ISSUED FOR CONSTRUCTION MARCH 28, 1996

PAVING PLAN						
ROUNDABOUT - QUORUM DRIVE & ADDISON CIRCLE						
ADDISON CIRCLE						
PHASE I PUBLIC INFRASTRUCTURE						
TOWN OF ADDISON, TEXAS						
Hull-Zollars, Inc./Engineering/Architecture						
Dallas, Fort Worth, Houston, El Paso, Phoenix, Tustin, Ontario, San Clemente						
DESIGN	DRAWN	APPR.	SCALE	DATE	PROJECT NO.	NO.
HZI	HZI	KAR	1"=20'	JAN 96	1822-04	20 137

RECORD DRAWING 5/1/98

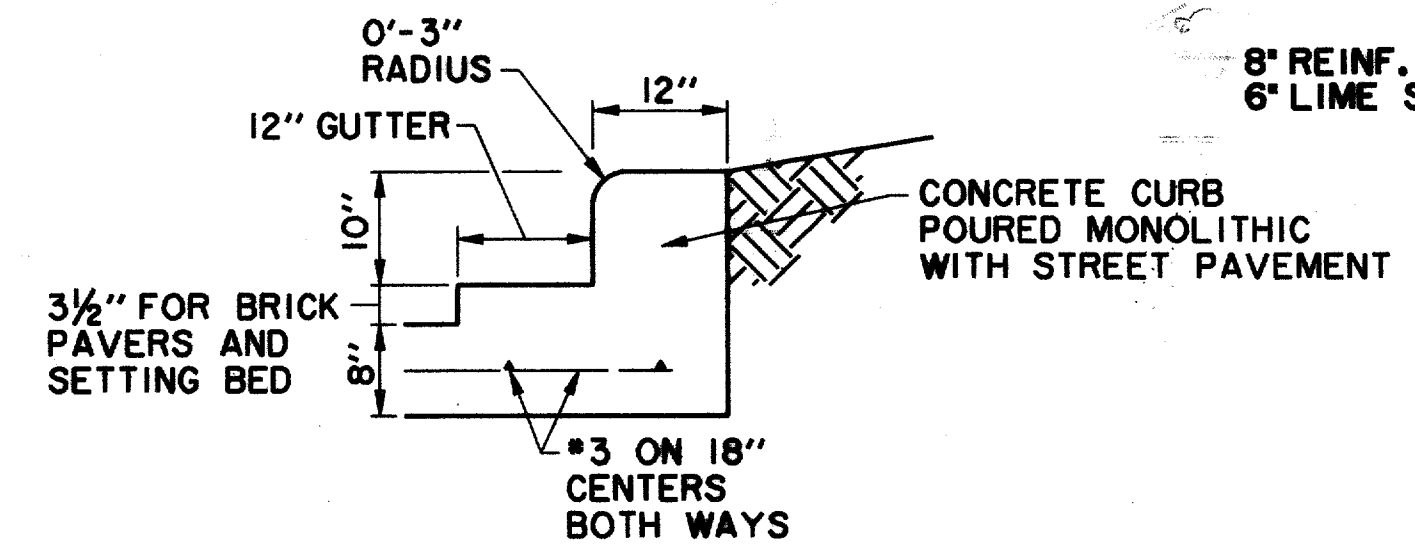
REVISED SIDEWALK EAST SIDE OF ROUNDABOUT 11/15/96

REVISED INTERIOR RADIUS TO 66.5 FEET. ADDED INTERIOR CURB DETAIL. DELETED RADIAL DROP SLAB BANDS 7/29/96

REVISED STEPS AT BUILDING 'A' 5/13/96
